Sea Link

Document 9.34.1: Applicant's Comments on Relevant Representations Identified by the ExA

Planning Inspectorate Reference: EN20026

Version: B
December 2025

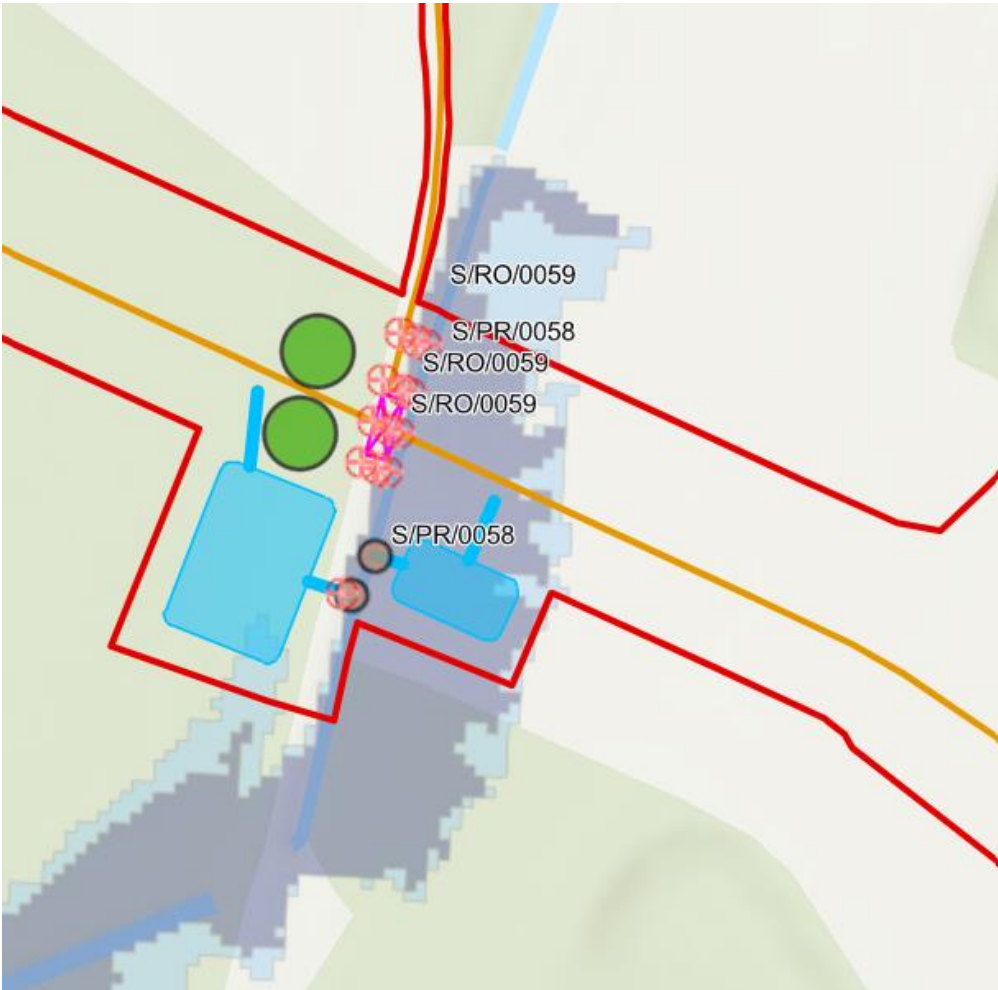
2.4.17. I	EA – HDD and flood defence monitoring ID: EA080 Environmental Statement APP-051 6.2.2.4 Part 2 Suffolk Chapter 4 Water Environment APP-292 6.8 Flood Risk Assessment Section/ pages/ table reference: 4.9.21 (APP-051) 4.3.23 (APP-292)	Solution Integrate monitoring of settlement and monitoring of flood defences with consideration emergency triggers and actions. Include the Environment Agency in the consideration of appropriate triggers and actions. These details should be submitted in a CEMP.	Commitment W12 in Application Document 7.5.3.2 CEMP Appendix B Register of Environmental Actions and Commitments (REAC) [APP-342] states that: <i>“At the Suffolk and Kent landfalls the offshore cables will be brought onshore using a trenchless technique, avoiding physical disturbance of several watercourses and areas of coastal floodplain. Monitoring of existing flood defences would be undertaken during the cable</i>

Reference	Summary of relevant representation	Recommendation	Applicant's response
	Issue HDD surface level monitoring is not linked to monitoring of flood defence and emergency response. Impact Settlement may compromise defences and flood risk management.		<i>installation in agreement with Environment Agency protocols to ensure no detriment to the integrity of the defences.”</i> This commitment provides the Environment Agency with the opportunity to influence the monitoring and to agree with the Applicant appropriate triggers and actions. However, the HDD at Kent is planned 20 m beneath the sea defences with the calculated worst-case long term settlement from the HDD as 3mm (<5 mm). Similarly the HDD at Suffolk is planned at 23 m beneath the existing natural coastal defences, with the calculated worst-case long-term settlement from the HDD of 3 mm (<5 mm). As such the level of settlement potentially induced by the HDDs is not of a scale that could impair coastal sea defences resulting in compromised defences and flood risk management. It is not therefore deemed necessary to monitor settlement, based on the WCS long term values cited.

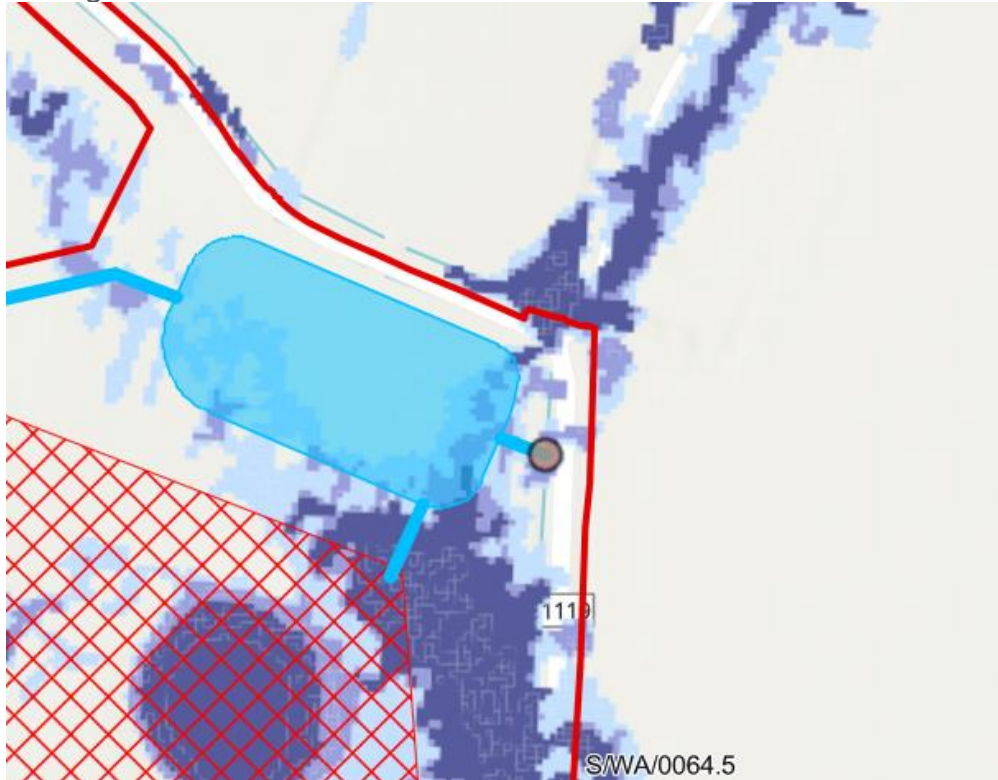
2.4.23.I	EA – Cofferdam location details ID: EA086 Environmental Statement APP-045 6.2.1.4 Part 1 Introduction Chapter 4 Description of the Proposed Project Section/ pages/ table reference: 4.6.172-4.6.174	Solution Confirmation or details of cofferdam locations to be submitted to ascertain exact location. Additional comments:	A commitment to not having a cofferdam within 8 m/16 m of flood defence is acceptable. Where required, an update to Application Document 7.5.3.2 CEMP Appendix B Register of Environmental Actions and Commitments (REAC) [APP-342] will be made following further agreement between the Applicant and Environment Agency.

Reference	Summary of relevant representation	Recommendation	Applicant's response
	Issue Unclear as to the exact location of temporary cofferdams at HDD exits. Impact May impact the stability or preclude access to flood defences/banks of a main if located nearby.	A FRAP will be required for any works within 8m of a fluvial river/flood defences, or 16m for a tidal river/flood defences.	Also note, cofferdams are temporary structures for use during construction only

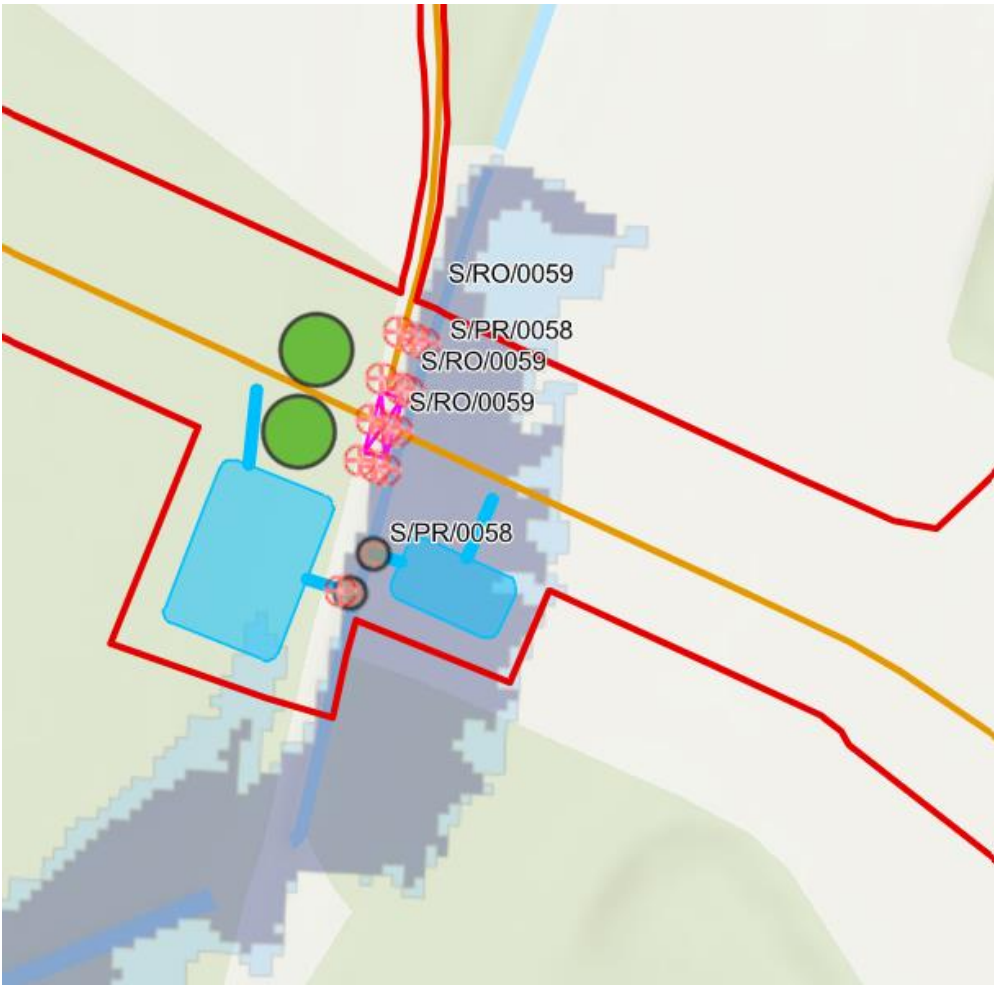
2.4.26. I	EA – River Stour material storage ID: EA089 Environmental Statement APP-292 6.8 Flood Risk Assessment Section/ pages/ table reference: Table 1.1 Issue Omission of details regarding mitigation for storage of materials within the River Stour floodplain. Impact	Solution Confirmation as to locations on where this may be required, and what the mitigations will be. These details should be submitted in a CEMP. Awareness that a FRAP will be required if it is not possible to remove any storage areas outside of the floodplain. Additional comments:	The Proposed Project is looking to use trackway within the flood zone in Kent to access the tower locations, however topsoil striping and stockpiling will still be required as will sub soil stockpiling at the tower locations. These stockpiles will be isolated so as not to create a barrier to the flow of flood water. The temporary bridge crossing will also require ramped approaches. A flood risk activity permit application will be submitted by the contractor for these activities. The photograph below shows similar trackway, isolated stockpiles and ramps used for the Canterbury to Richborough project.

Reference	Summary of relevant representation	Recommendation	Applicant's response
	Potential to alter or impede flood flow paths and thereby increase flood risk.	It is accepted and noted within the FRA that no construction materials are to be stored within Flood Zone 3 (W06), however it later explains that this may not be possible in the River Stour Floodplain and mitigation measures will be applied. Any activity (other than an allowed activity) on a floodplain can be considered a Flood Risk Activity under Definition G of Schedule 25 of the EPR (2016) legislation if the work is likely to divert or obstruct flood waters. Excavation or changes in ground level has the potential to do so. A Flood Risk Activity Permit will need to be applied for.	 Commitment W06 secures mitigation where storage of materials cannot avoid Flood Zone 3. Examples include using model outputs to inform the placement of soil during construction and aligning soil stockpiles to avoid impeding key flood flow routes. Given that the River Stour is a tidally dominated river within the Order Limits, in accordance with the guidance that accompanies the National Planning Policy Framework compensation for losses of floodplain storage are not required. This has also been previously agreed with the Environment Agency.
